**NOTICE OF A REGULAR MEETING
OF THE DESIGN REVIEW BOARD OF THE TOWN OF CLARKDALE**

STAFF REPORT

Agenda Item: Discussion/possible action DRB-091061 – A Design Review for fencing, directional signage, aluminum siding, and landscape plan at the Chateau Tumbleweed – 1151 State Route 89A, parcel # 406-26-313A.

Meeting Date: June 3, 2015

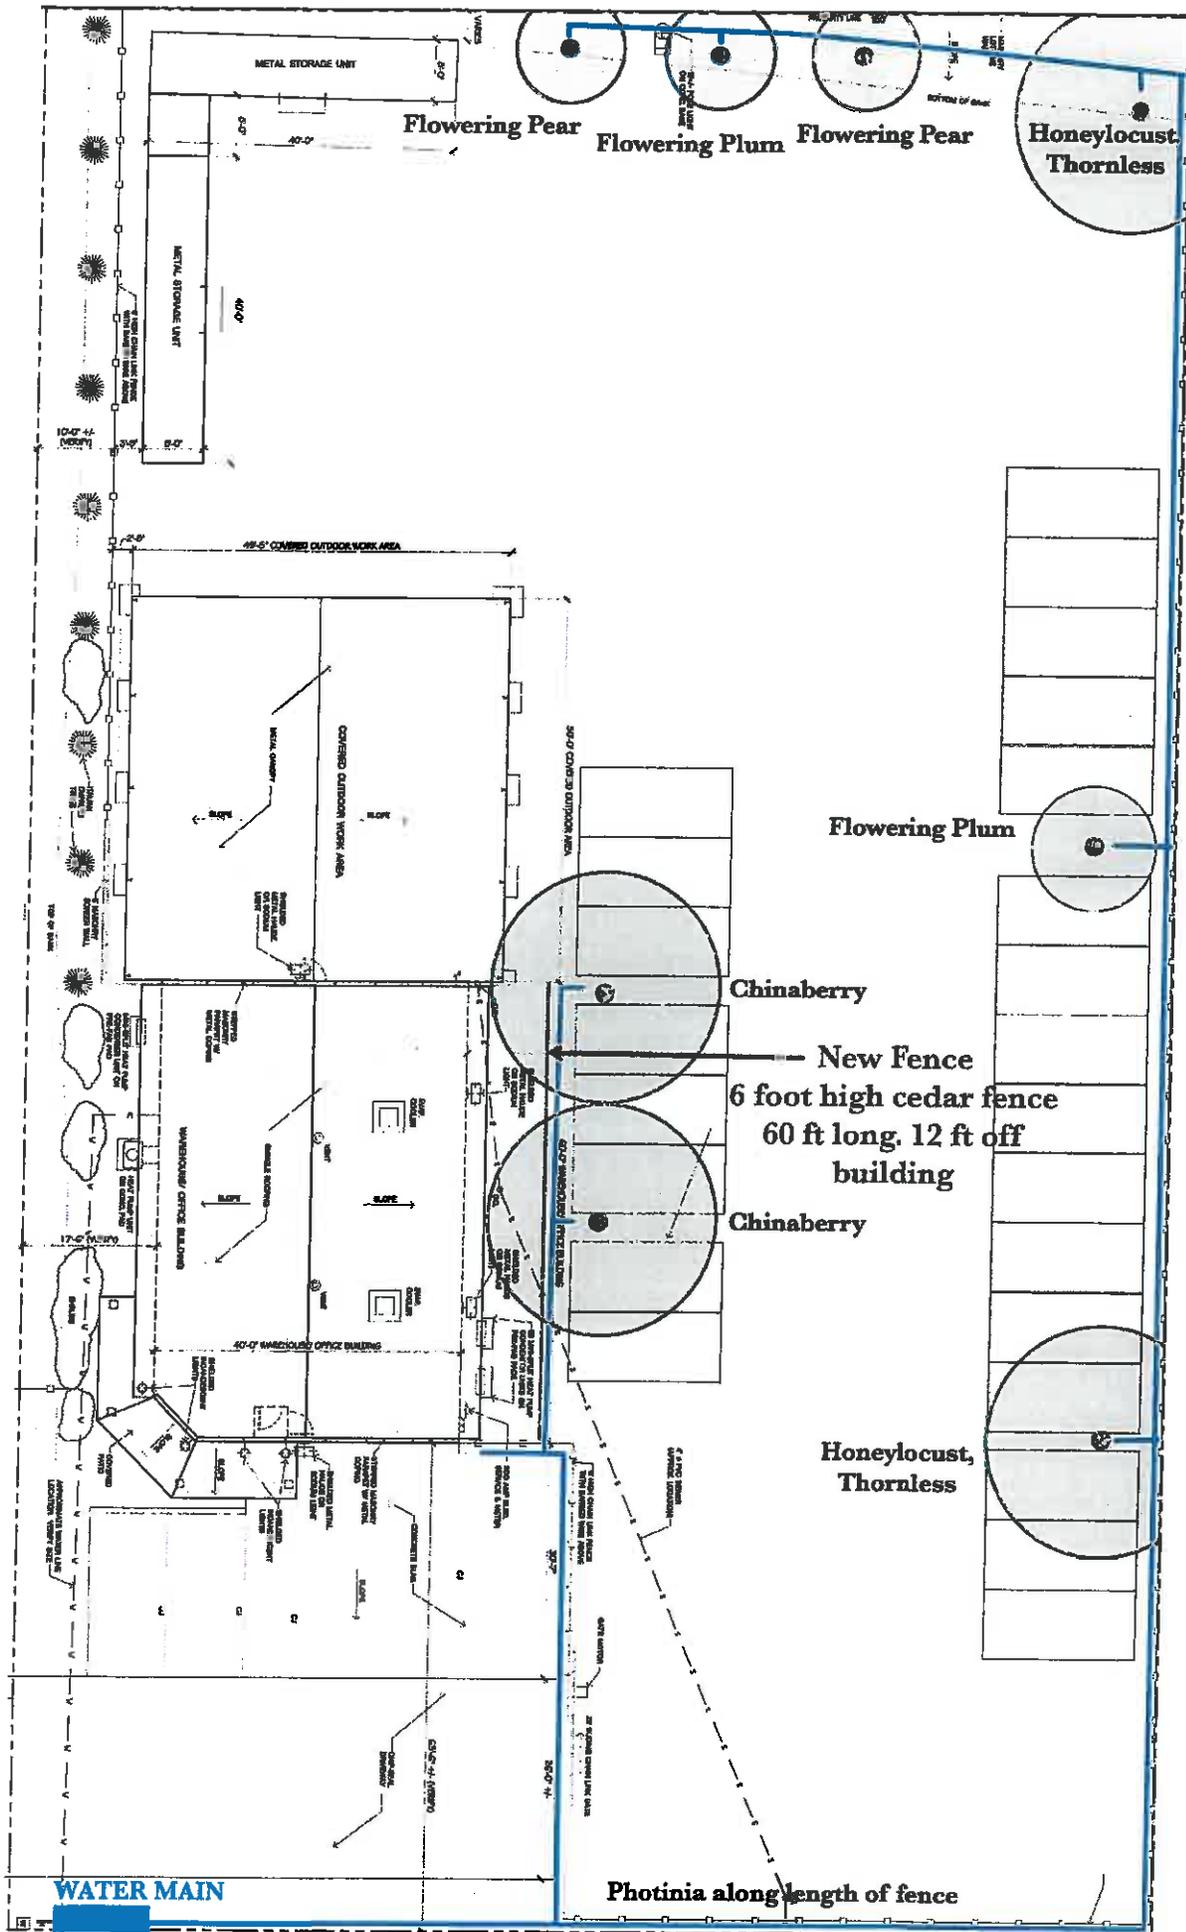
4. (8) Native trees and shrubs to be placed along fence will be (2) Chinaberry, (2) Honeylocust Thornless, and (4) Flowering Plum. The trees proposed on the landscaping plan are all on the approved plant list. Most of the irrigation is usable throughout the property; some small irrigation expansions will be plumbed to trees. (See attached renderings.)

11. Landscaping shall be visually compatible with the landscaping around the buildings, structures and places to which it is related. The landscape depicted in the design submitted by the applicant preserves the natural desert environment. All new plants are from the Clarkdale approved plant list.

1. Installation of the fencing and the aluminum paneling shall be inspected and approved by the Town's Building Official.
2. All landscaping must conform to *Zoning Code Chapter 9, Section 9-8 Plant List*.

New Fence
6 foot high cedar fence
60 ft long, 12 ft off
building

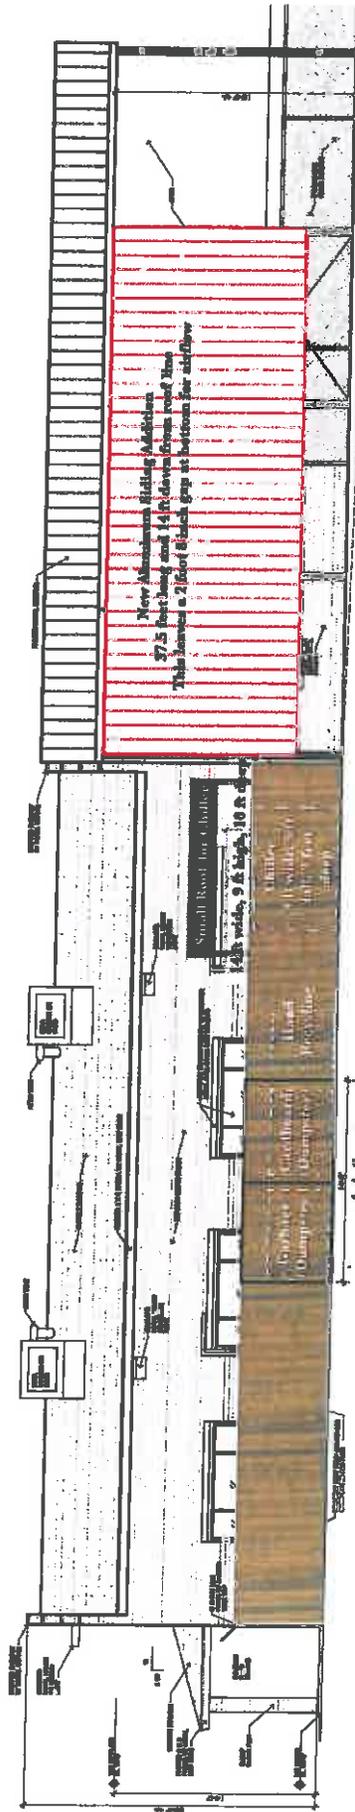
1. The proposed fencing will be 60 linear feet of 6' high cedar fence in front of the electric panels, two dumpsters, the recycling area, and the chilling unit. A 14' wide double gate will be added for entrance to the garbage and cardboard dumpsters. (See attached renderings and photos.)

2. The proposed aluminum siding will be 37.5' long and 14' down from roof line leaving a 2' 8" gap at the bottom for air flow. The aluminum siding will be on the Northwest side of the covered outdoor work area. The chilling unit will have a small roof constructed over it to protect the unit from rain. (See attached renderings and photos.)

10. Garages, carports, sheds, enclosures, walkways, stairways, and landings shall be visually compatible with buildings and structures to which they are related. Applicant complies.
